Hartland Township Planning Commission Meeting Agenda Memorandum

Subject: Site Plan #24-010 Redevelopment of site – proposed restaurant with drive-through service (Chick-fil-A), Planned Development (PD) Concept Plan (10382 Highland Road)

Date: September 26, 2024

EXTERIOR ELEVATION

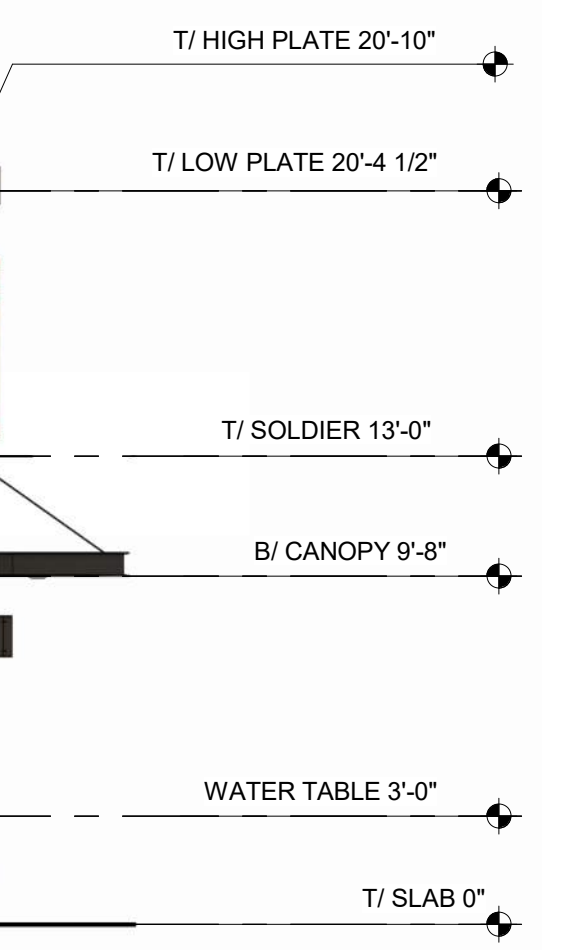
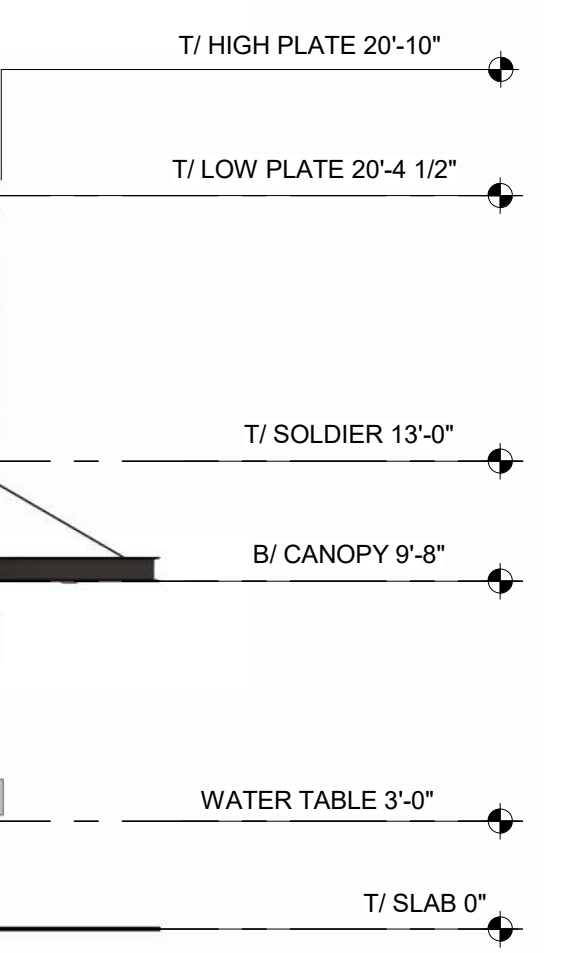
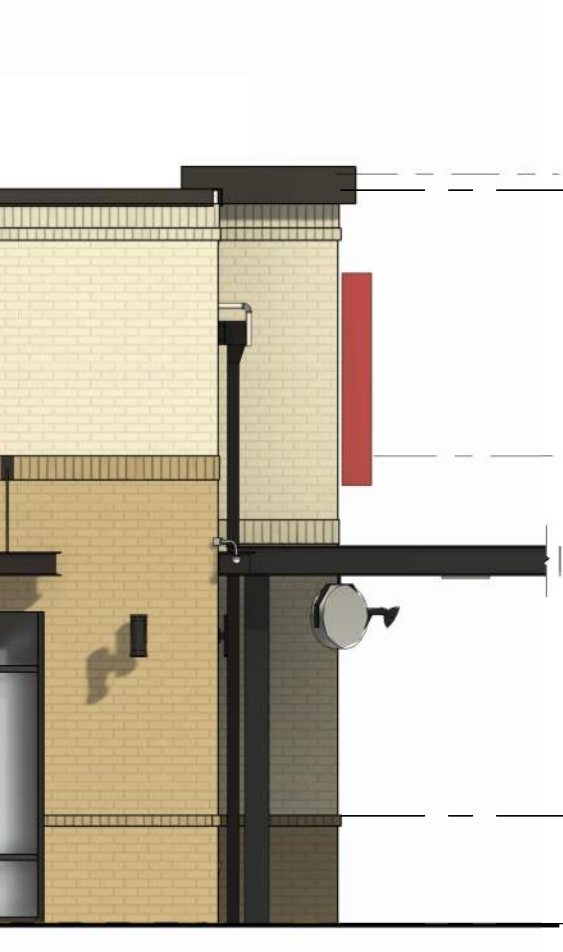
The building elevations show brick veneer as the dominant façade material in light and dark brown tones. Bronze trim and paint are used for windows and other accents. Façade material percentages are not provided but will be required with Preliminary PD site plans. The building height is stated as 20'-10". The next set of building elevations must show the outline of each roof-mounted mechanical unit. All roof-mounted mechanical units must be screened on all sides by parapet walls.

The metal canopy structure has a bronze finish and is approximately 9'-6" in height, as measured to the underside of the structure.

A Pattern Book with specific design details was not submitted with the Concept Plan. Detailed building elevations and floor plans should be submitted with the Preliminary PD Site Plan application. The building elevations should include a chart listing the façade materials and percentage of each material, for every elevation.
